TO:	CHAIR AND MEMBERS LONDON ADVISORY COMMITTEE ON HERITAGE MEETING ON WEDNESDAY, SEPTEMBER 11, 2013
FROM:	JOHN M. FLEMING MANAGING DIRECTOR, LAND USE PLANNING AND CITY PLANNER
SUBJECT:	HERITAGE ALTERATION APPLICATION BY: K. MILLSON 300 DUNDAS STREET

Appendix 3: Concept Photos showing possible options

Option 1(Applicant’s Preferred Option)

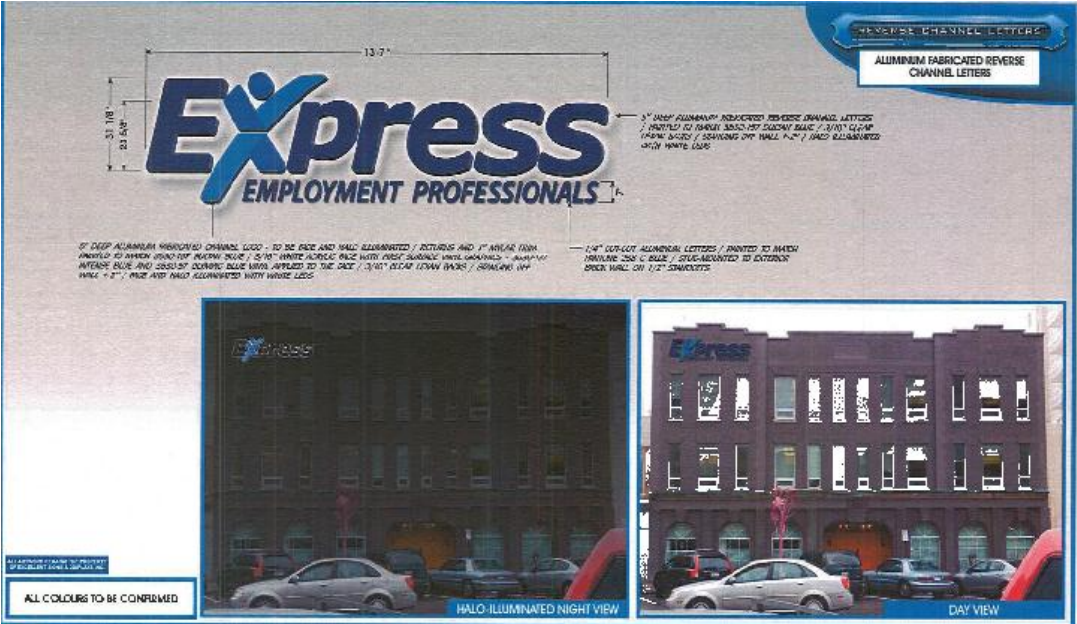
A previous business located at this address, had a prominent sign placed centred on the third floor. (Appendix 2- Photos.) In the opinion of the heritage planner, the proposed new sign is contrary to the new Guidelines in two respects. First, is the use of internal illumination, specifically discouraged, except in particular circumstances. Secondly, the preferred placement is directly over an identified heritage feature- the date stone identifying the **Wyatt Building, 1927**. This is one of three identified features along with the painted brick and the stone capping along the roofline.

The owners prefer Option 1 with the internally illuminated sign at the top centre of the façade. As mentioned, the owners have indicated a willingness to place an interpretive plaque elsewhere on the façade to identify the building’s historic name and date of construction.

Staff recommend that this sign be placed either on the top left side of the third floor façade or above the main entrance on the second floor with no internal illumination being used. Exterior mounted up lighting could be supported as a minor alteration to the exterior façade with this option.
